marantz® SERVICE BULLETIN		Date: 15-May-2003	Model SR7300
		Page: 1/1	REF.NBR: MZ03-003
Circulation:		Subject:	
Application:		Broken Knob	
x for information customer complaint in case of service mandatory		Int.ref:	
MZxxxxx01xxxx to MZxxxxx13xxxx

marantz® SERVICE BULLETIN		Date: 15-May-2003	Model SR7300
		Page: 1/2	REF.NBR: MZ03-006
Circulation:		Subject:	
Application:		Improvement of high tone noise	
x for information customer complaint in case of service mandatory		Int.ref:	
ALL

marantz® SERVICE BULLETIN		Date: 15-May.-2003	Model: SR7300,SR6300
		Page: 1 / 1	REF.NBR: MZ03-018
Circulation:		Application:	
x for information customer complaint in case of service mandatory		See Below	
		Subject: The problem that the remote controller can't learn other the remote controller .	
		Int.ref:

marantz® SERVICE BULLETIN		Date: 28-Sep-2003	Model: SR7300/K1G
		Page: 1 / 1	REF.NBR: MZ03-041
Circulation:		Subject:	
Application:		The MAINS CORD changed from AC IN socket type to fixed type. (/K1G version only)	
x for information customer complaint in case of service mandatory	From MZxxxxxxx30xxxx

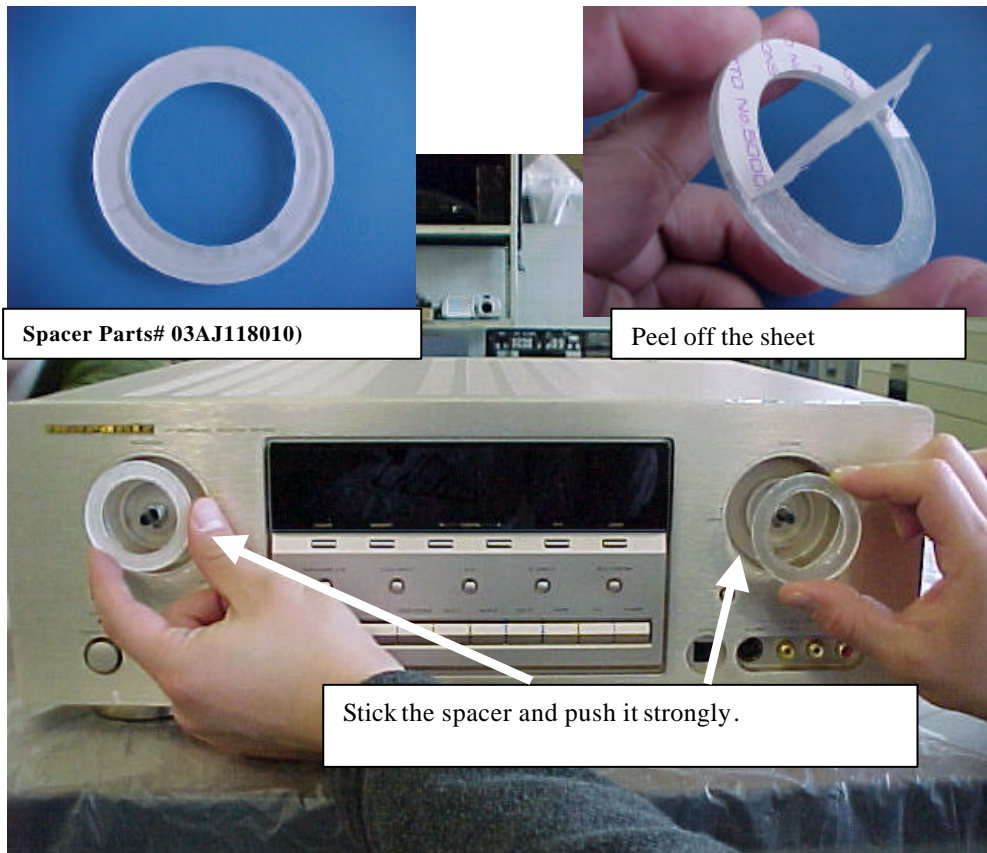
Broken Volume or Selector knob by transportation.

A clearance between the front panel and knob were a little large and get stress to the volume shaft.

Add the spacer to the front panel as follows.
(Spacer : parts No. 03AJ118010)

This improvement has been done in the production line after the LOT number "14" and later (The LOT number is "##" of serial number "MZxxxxxx##xxxx".)

Solution 1 (For lot 01 to 15)

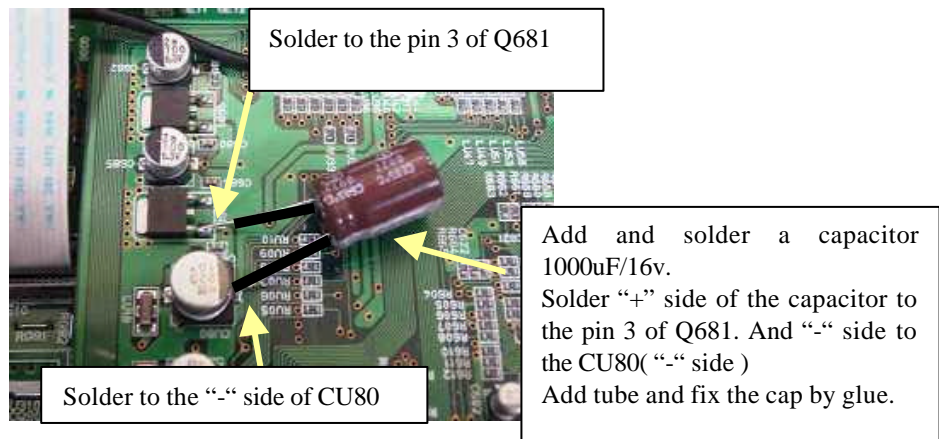
High tone noise can be heard a little from speaker.

- 1) Cut a jumper wire [U304] on the PS04 board.

- 2) Add a capacitor < 1000uF/10V : Parts # OA10801020> between the pin 3 of the Q681 and the “-“side of the CU80 as follows.

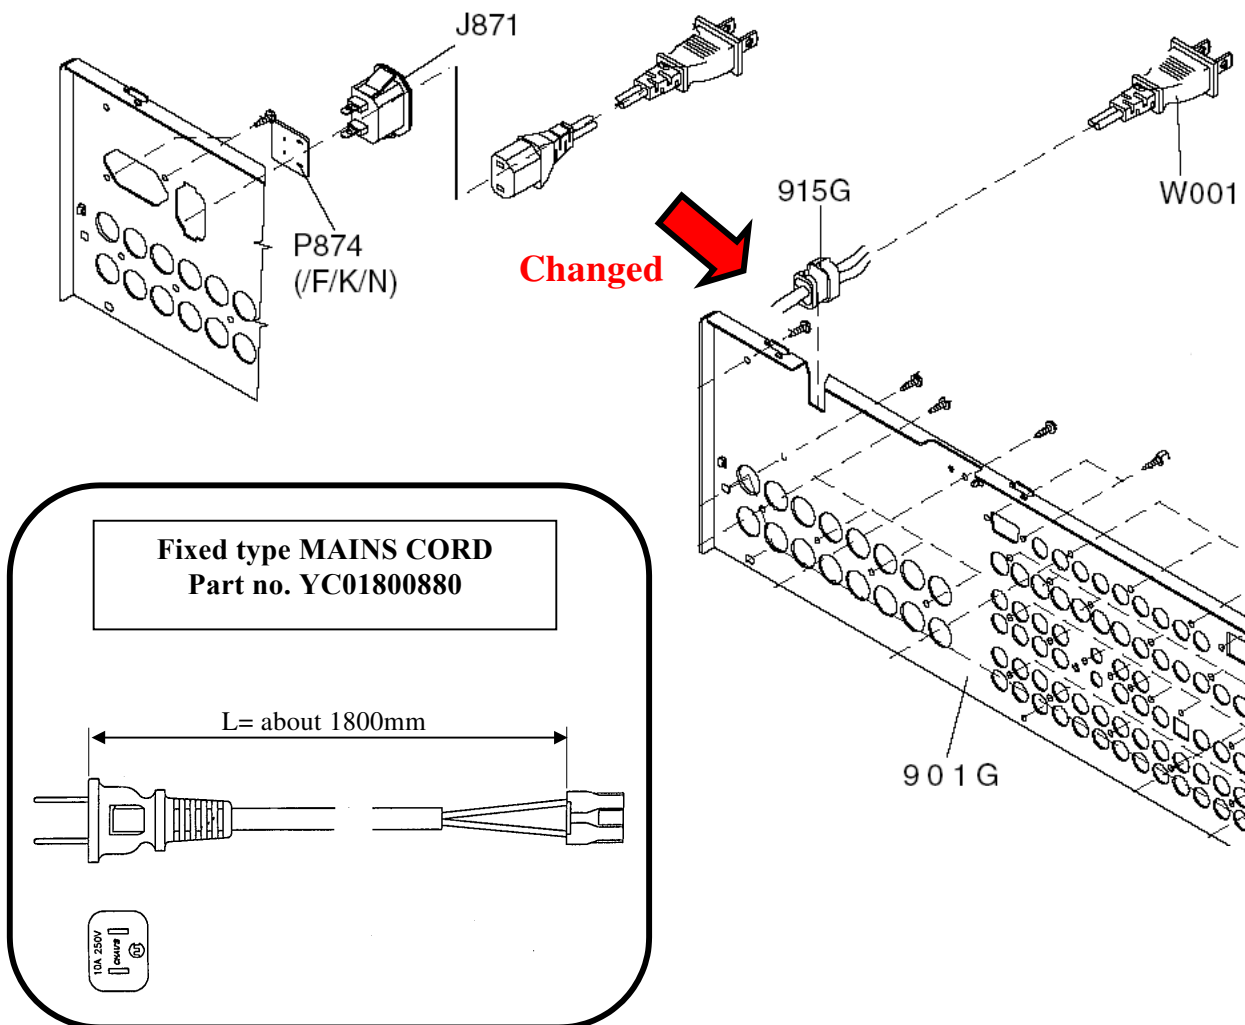
It depends on the Chinese safety standard requirement.

The following parts are changed.

1. MAINS CORD is changed from (Z011) part no. ZC01803090 to (W001) part no. YC01800880 .
2. MAINS CORD BUSH (915G) part no. 450H259010 (NIFCO #2271) is added.
3. REAR PANEL (901G) is changed.(This is not supply of the service spare part)
4. AC IN socket is deleted.
